UNITED STATES PATENT AND TRADEMARK OFFICE

APPLICATION NO.	FILING DATE	FIRST NAMED INVENTOR	ATTORNEY DOCKET NO.	CONFIRMATION NO.
09/886,550	06/21/2001	Stephen L. Clark	4524B	8232

Office Action Summary

Attachment A

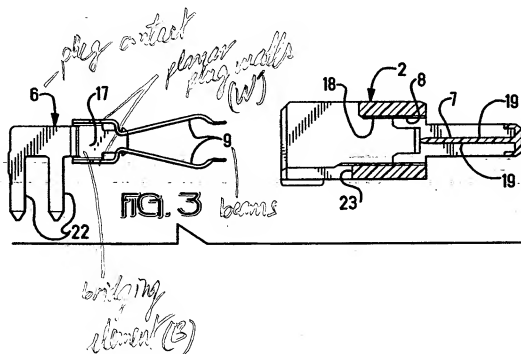
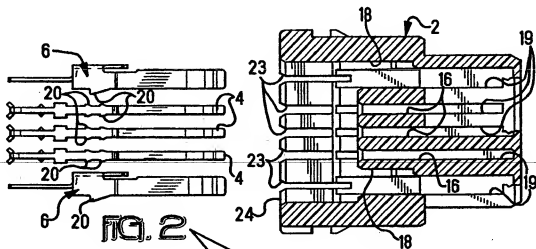
The disclosure of Davis shows each and every element set forth in these claims. For example: Figs. 3, 9, 11 and Attachment A show a power receptacle 6 with a pair of spaced apart planar walls (W), a power plug 6 having space apart planar walls (W'), each wall having a beam 9 extended therefrom.
